**Comments on the proposal for draft amendments to Regulation No. 110
(ref. document TRANS/WP.29/GRPE/2005/4)
including a new proposal for amendments to Regulation No. 110.**

Transmitted by the expert from the Netherlands

Figure 1a: Automatic valve on each cylinder

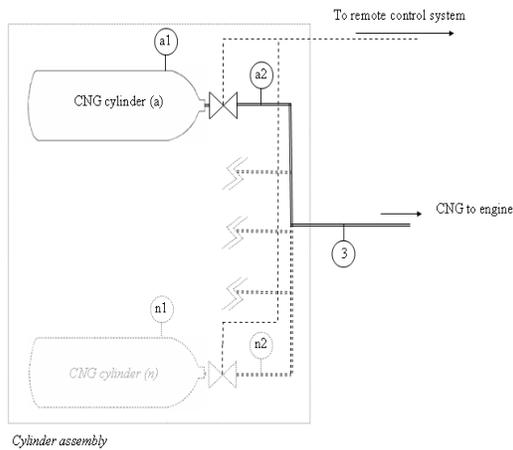
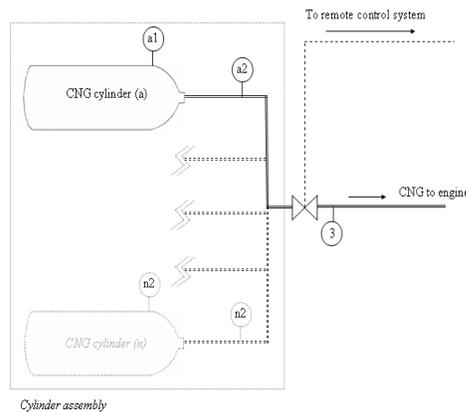
In figure 1a an assembly of n-containers is presented with an automatic valve installed on each cylinder. In figure 1b the same assembly is shown, however in this case only a single automatic valve is installed on the cylinder assembly.

In each figure a number of 3 study nodes (1, 2 and 3) are defined. For each of these nodes the consequences of a LOC are studied in more detail. The numbering of these scenarios refers to the numbering of the study nodes.

Scenario a1 /./ n1: Leakage of a CNG cylinder

A leakage at location 1 will result in the release of CNG from the cylinder. The total amount of gas that is released in this scenario depends on the configuration and is specified below.

- 1) *Installation according to R110* (see figure 1a); Due to the presence of the automatic valve directly mounted on the cylinder, the release will be limited to the content of the cylinder involved.
- 2) *Installation according to draft amendments* (see figure 1b); Due to the presence of the automatic valve mounted downstream of the cylinder assembly the release will not be limited to the content of the cylinder involved but include the content of the whole cylinder assembly.

Scenario a2 /./ n2: Leakage of an interconnecting fuel line

A leakage at location 2 will result in a release of CNG from the interconnecting fuel line. The total amount of gas that is released in this scenario depends on the configuration and is specified below.

- 1) *Installation according to R110* (see figure 1a); Due to the presence of the automatic valve directly mounted on the cylinder, the release will be limited to the content of the interconnecting fuel lines and the main fuel line. The automatic valve will prevent the release of gas from the cylinder.
- 2) *Installation according to draft amendments* (see figure 1b); Due to the presence of the automatic valve mounted downstream of the cylinder assembly the release will not be limited to the content of the interconnecting fuel lines but include the content of the whole cylinder assembly.

Scenario 3: Leakage of the main fuel line

A leakage at location 3 will result in the release of CNG from the main fuel line. The total amount of gas that is released in this scenario depends on the configuration and is specified below.

- 1) *Installation according to R110* (see figure 1a); Due to the presence of the automatic valve directly mounted on the cylinder, the release will not be limited to the content of the main fuel line but also include the content of the interconnecting fuel lines.
- 2) *Installation according to draft amendments* (see figure 1b); Due to the presence of the automatic valve mounted downstream of the cylinder assembly the release will be limited to the content of the main fuel line. The automatic valve will prevent the release of gas from the interconnecting fuel lines.

From this table it can be concluded that in case of a LOC at location 1 or 2, the outflow is less in case the automatic valve is mounted directly on each cylinder. This difference in the amount of gas that is involved is significant, i.e. a factor of (n-1). In case of a LOC at location 3, the outflow is less in case the automatic valve is mounted on the cylinder assembly. This difference in the amount of gas that is involved is minor, due to the fact that the content of the interconnecting lines is rather low compared to the content of the main fuel line.

Based on the analysis of scenarios as described above it is noticed that the probability of failure of the automatic valve is larger for a configuration in accordance with R110. On the other hand, the consequences of a LOC are larger in case of a configuration in accordance with the draft amendments. In order to determine the overall consequences for the safety of the system it is necessary to calculate the risk (i.e. quotient of probability and consequence). At this moment there is however a lack of insight in the risks related to the two configurations. It is therefore not possible to justify the statement as presented in [1].

“17.5.1.1. The flow of natural gas from a container or container assembly into the fuel supply line shall be secured with an automatic valve (idle closed). This valve shall be mounted directly on or within either every container or one container in a container assembly.”
